SUBJECT: NuScale Power, LLC Response to NRC Request for Additional Information No. 164 (eRAI No. 8935) on the NuScale Design Certification Application

NuScale Response to NRC Request for Additional Information eRAI No. 8935

eRAI No.: 8935

NRC Question No.: 03.07.02-23

Figure 3-9. Soil Type 7 - Comparison of Combined Free-Field East-West (X) ARS at Depth 85', Capitola Input, $\alpha = 0^\circ$, 17° , 30° .

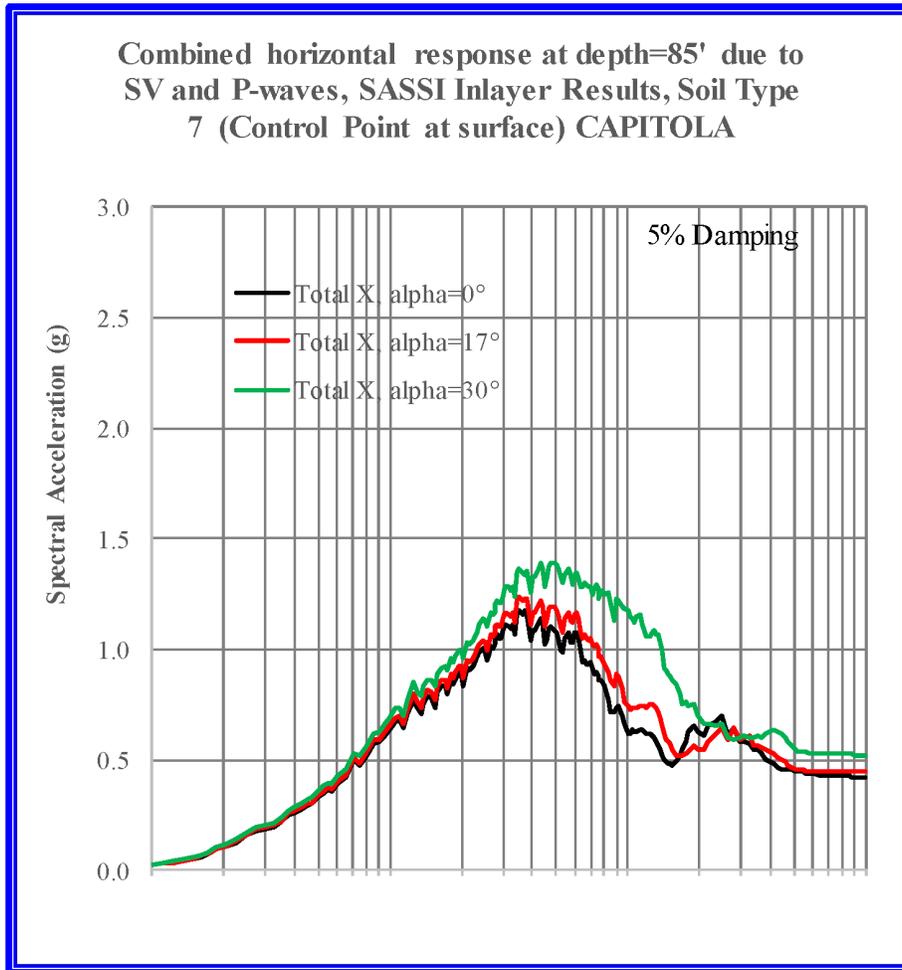
The results presented in Section 3.2 show the effect of the coupling terms due to non-vertically propagating waves. The $\alpha = 0^\circ$ (vertically propagating) curves represent the CSDRS case. These results show that, even though the horizontal input motion at the surface is the same for all angles of incidence of inclined SV waves (Figure 3-2), the motion at the foundation depth exceeds those of the CSDRS (or FIRS) even without including the coupling terms from inclined waves. For example, see Figure 3-8. Once coupling terms from inclined waves are considered, the motion at the foundation depth far exceeds those of the CSDRS responses. For example, see Figure 3-9.

Therefore, the coupling terms from inclined waves should not be included in the response calculation, in order to properly maintain the as-defined, design-basis seismic inputs, the CSDRS and CSDRS-HF.

Figure 3-16. Soil Type 7 - Free-Field Vertical (Z) ARS at Depth=85', Capitola Input, $\alpha = 30^\circ$.

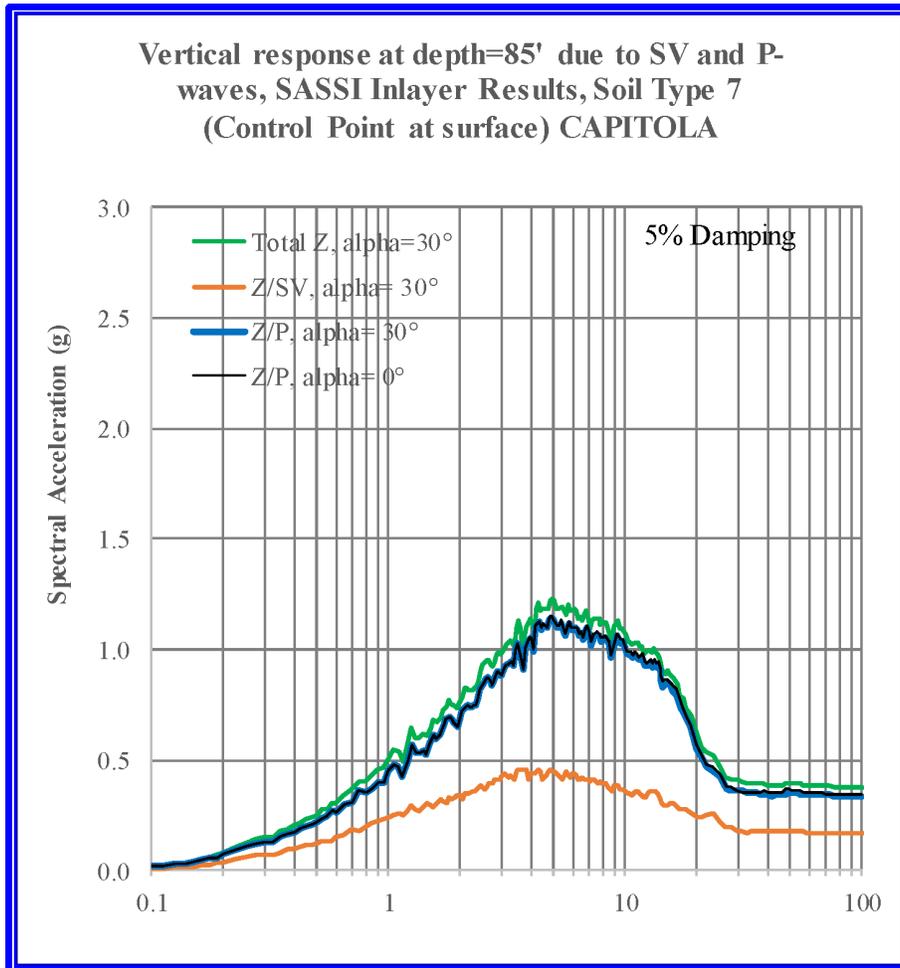
For P-waves, the vertical in-column response motion from inclined waves is close to that of the vertical motion obtained from the CSDRS when the coupling term is not considered. For example, see Figure 3-16.

Figure 5-5. RXB - Uncombined East-West (X) ISRS, Node 3996, El. 24'-0", Top of Basemat, NW Corner, Capitola Input.

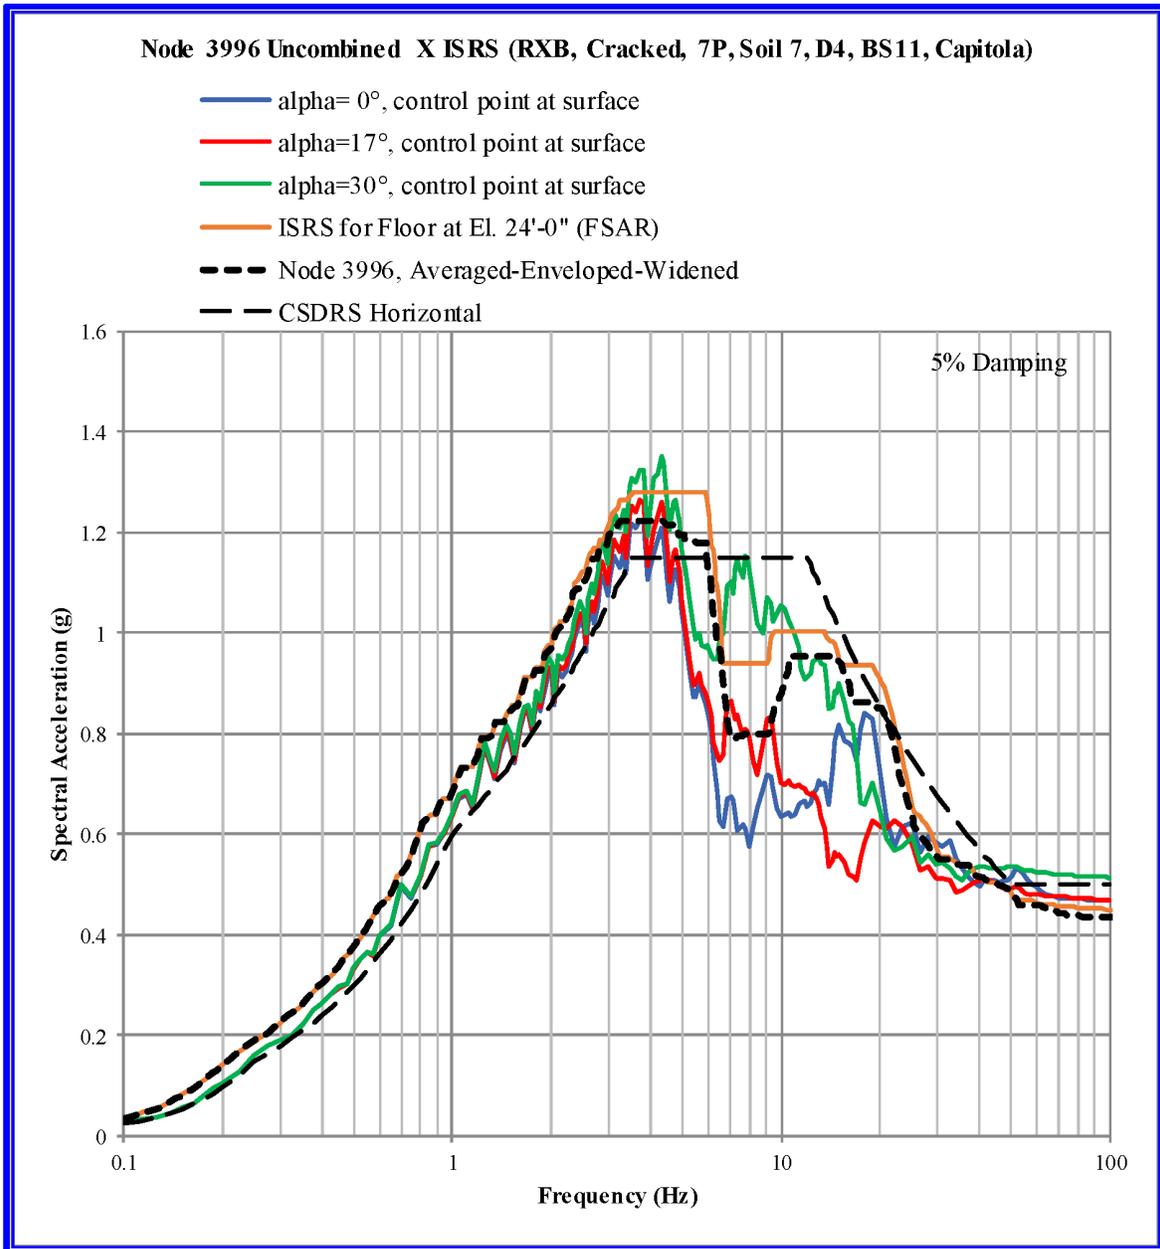
This section presents comparisons of the uncombined ISRS at Node 3996 (El. 24'-0", top of basemat, northwest corner). Note that the $\alpha=0^\circ$ curve represents the response to the CSDRS motion. The $\alpha=0^\circ$, $\alpha=17^\circ$, and $\alpha=30^\circ$ curves do not include the coupling terms. Also note that the CSDRS at rock outcrop (thin dashes) is shown for reference only. In Figure 5-5, the $\alpha=17^\circ$ curve is enveloped by the floor ISRS, except for a band from 50 to 60 Hz. The $\alpha=30^\circ$ curve is enveloped by the floor ISRS, except for a band from 3.5 to 4.5 Hz, from 6 Hz to 11 Hz, and from 40 Hz to 100 Hz. When the average ISRS of the five time histories is used, the exceedances are expected to be smaller.

Figure 5-6. RXB - Uncombined North-South (Y) ISRS, Node 3996, El. 24'-0" Top of Basemat, NW Corner, Capitola Input.

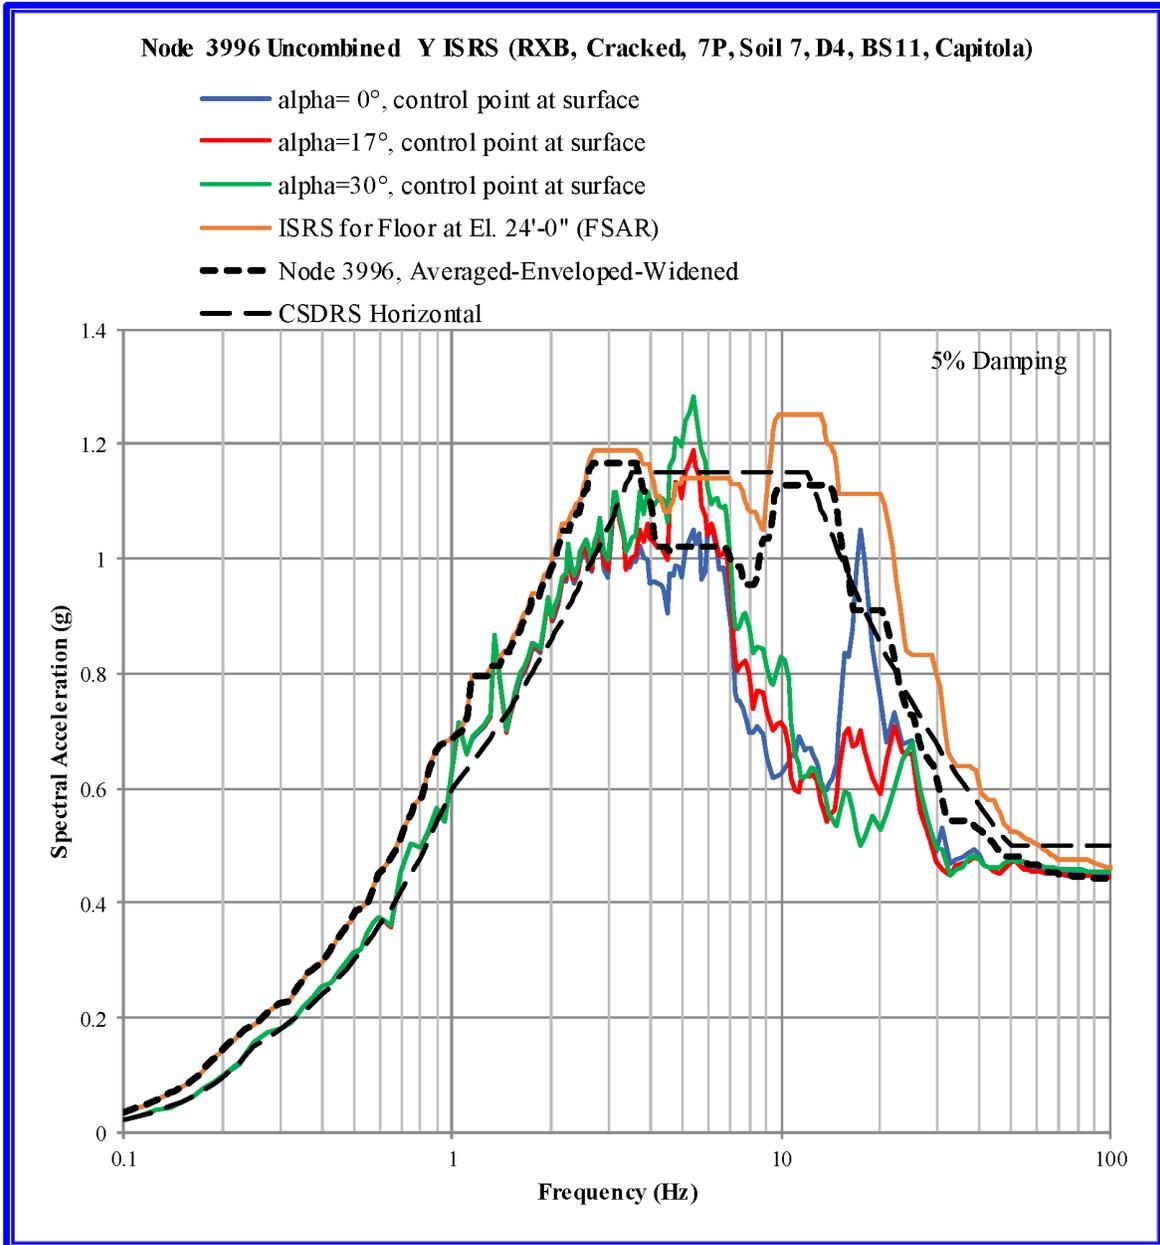
In Figure 5-6, the floor ISRS curve envelopes the $\alpha=17^\circ$ and $\alpha=30^\circ$ curves, except for a peak at about 1.3 Hz and a band from 4.5 Hz to 6 Hz. When the average ISRS of the five time histories is used, the exceedances are expected to be smaller.

Figure 5-8. RXB - Uncombined East-West (X) ISRS, Node 5642, El. 24'-0" Top of Basemat, NE Corner, Capitola Input.

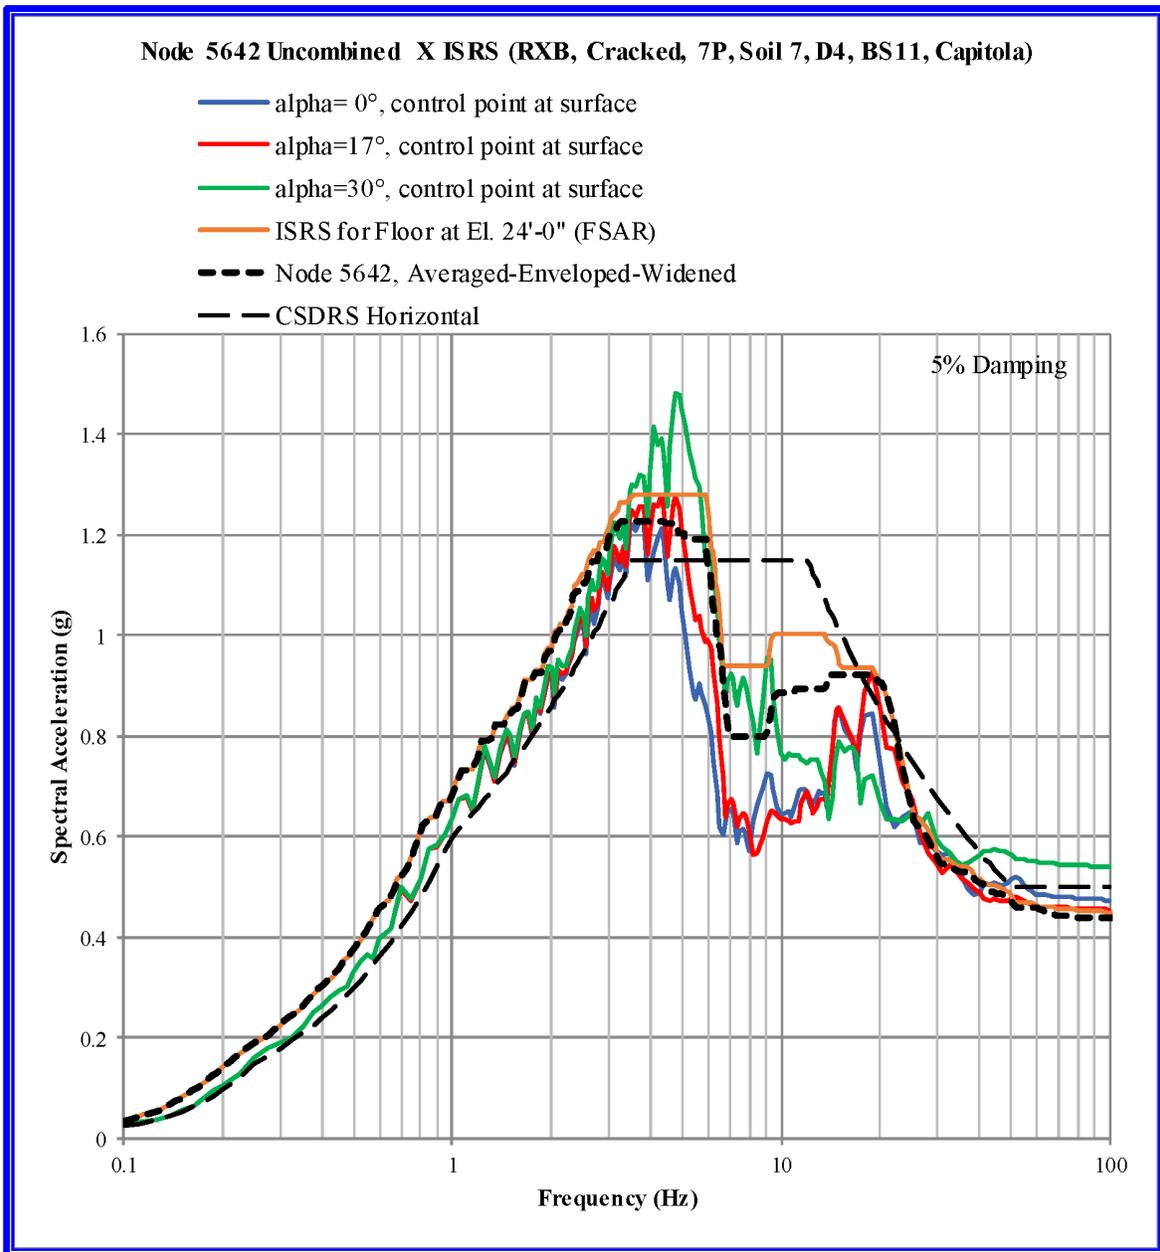
In Figure 5-8, the $\alpha=17^\circ$ curve is enveloped by the floor ISRS. The $\alpha=30^\circ$ curve is enveloped by the floor ISRS, except for a band from 3.5 to 6 Hz, and from 35 Hz to 100 Hz. When the average ISRS of the five time histories is used, the exceedances are expected to be smaller.

Figure 5-9. RXB - Uncombined North-South (Y) ISRS, Node 5642, El. 24'-0", Top of Basemat, NE Corner, Capitola Input.

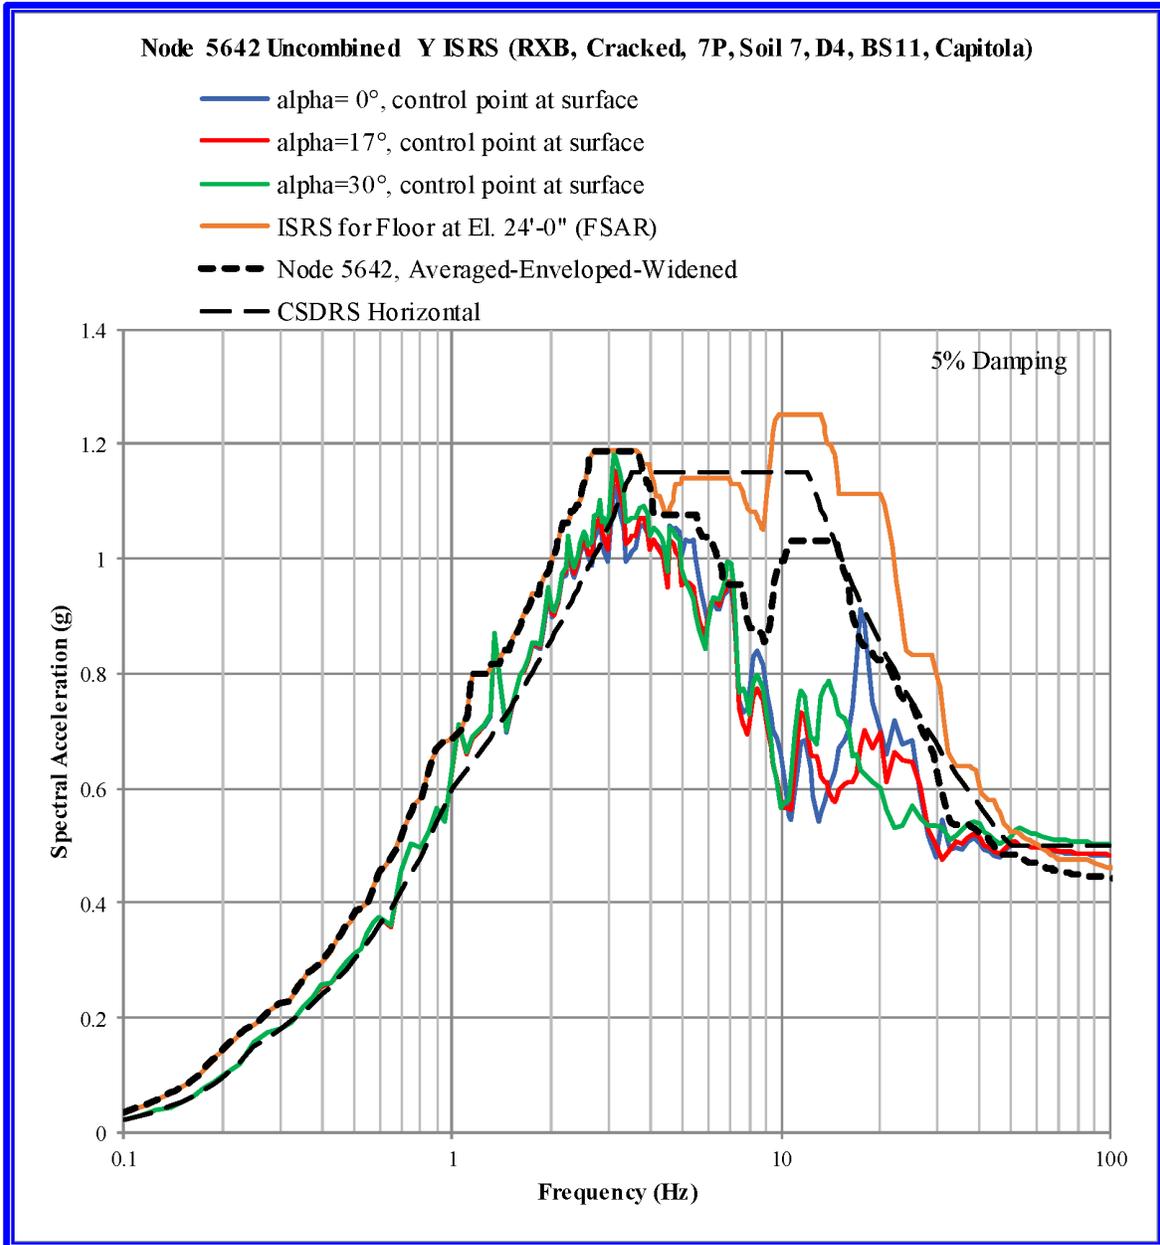
In Figure 5-9, the floor ISRS curve envelopes the $\alpha=17^\circ$ and $\alpha=30^\circ$ curves, except for a peak at about 1.3 Hz and from 50 Hz to 100 Hz. When the average ISRS of the five time histories is used, the exceedances are expected to be smaller.

Figure 5-17. RXB - Uncombined East-West (X) ISRS, Node 29098, El. 167', Roof, SW Corner, Capitola Input.

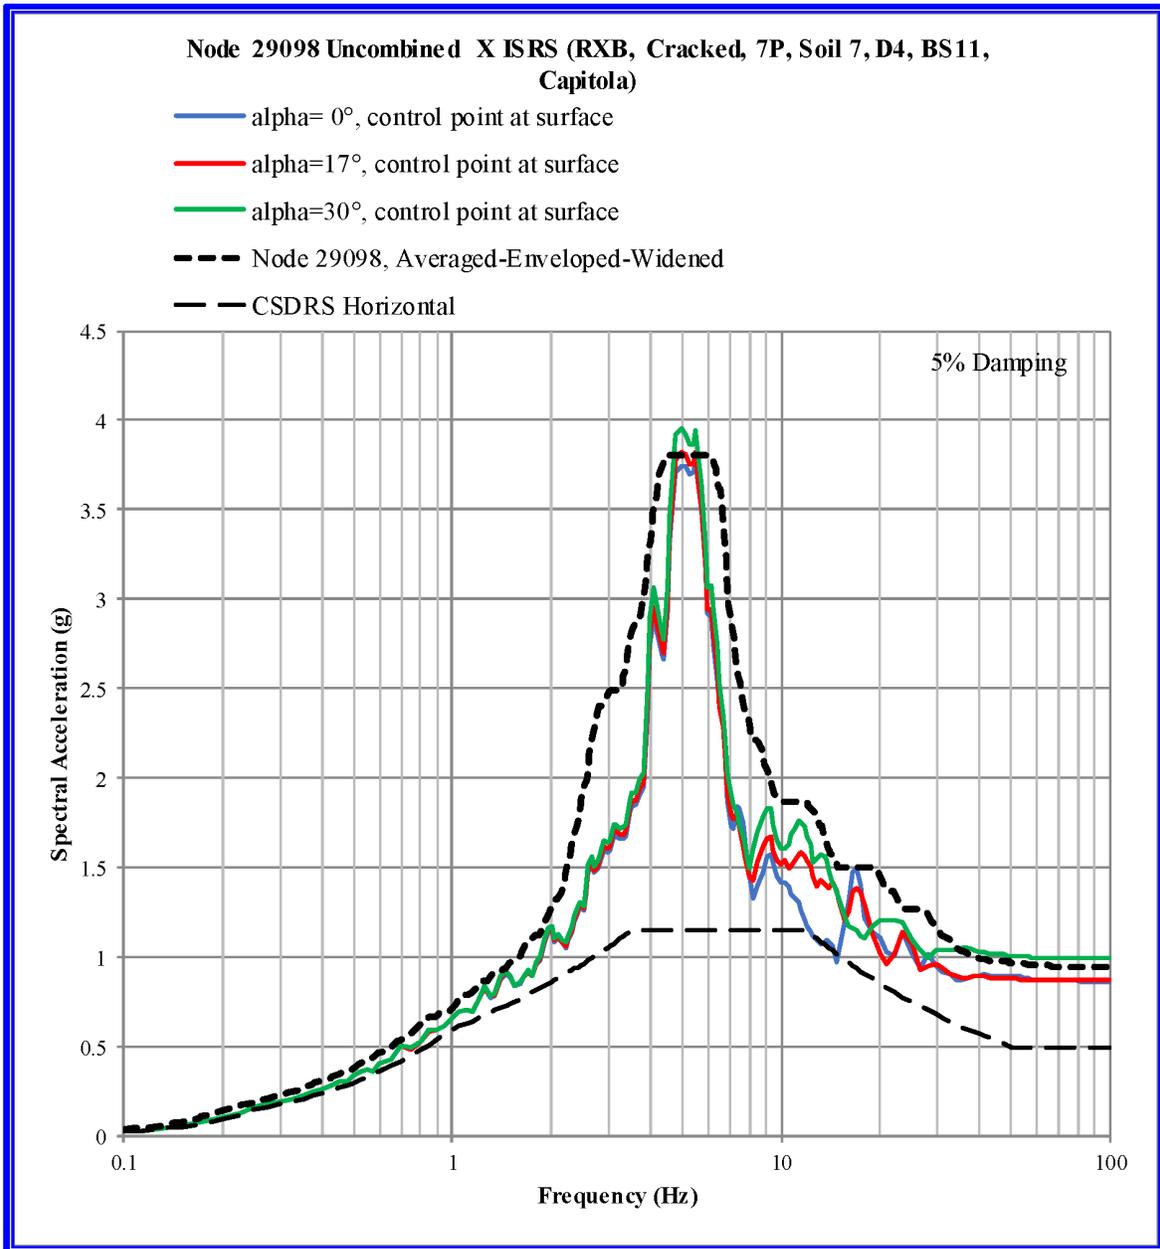
There are no floor response spectra to compare at this elevation, however, the averaged-enveloped-widened spectra at node 29098 are shown for comparison. In Figure 5-17, the $\alpha=17^\circ$ curve is enveloped by the averaged-enveloped-widened ISRS. The $\alpha=30^\circ$ curve is enveloped by the averaged-enveloped-widened ISRS, except for a band from 4.5 to 5.5 Hz and from 35 Hz to 100 Hz. When the average ISRS of the five time histories is used, the exceedances are expected to be smaller.

Figure 5-18. RXB - Uncombined North-South (Y) ISRS, Node 29098, El. 167', Roof, SW Corner, Capitola Input.

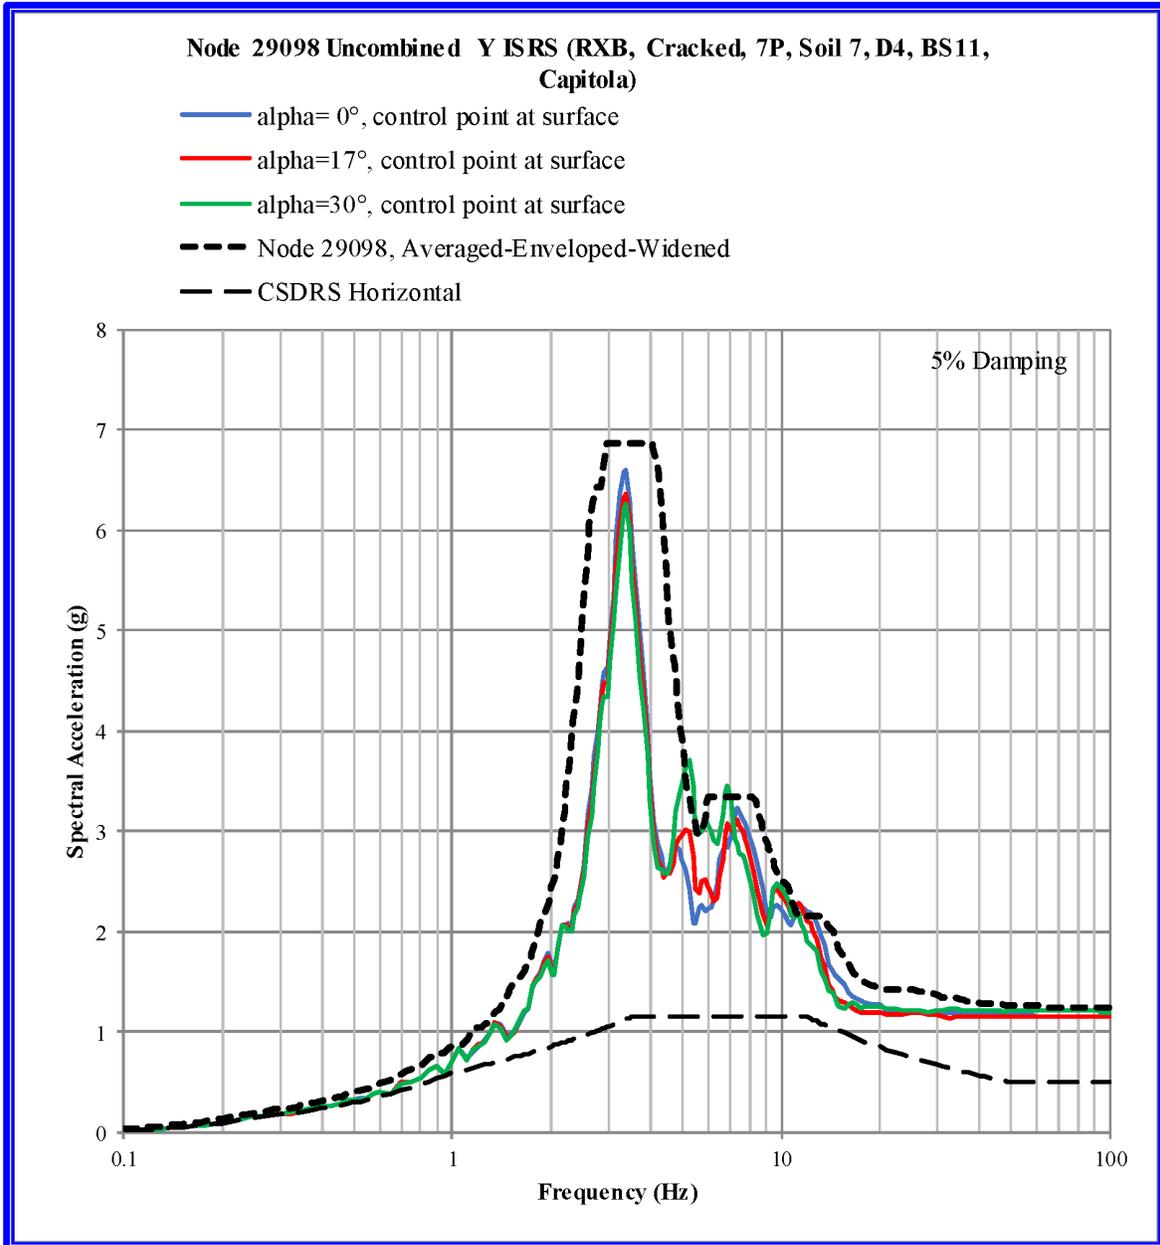
In Figure 5-18, the averaged-enveloped-widened ISRS curve at node 29098 envelopes the $\alpha=17^\circ$ and $\alpha=30^\circ$ curves except for peaks at about 5 Hz and 7 Hz. When the average ISRS of the five time histories is used, the exceedances are expected to be smaller.
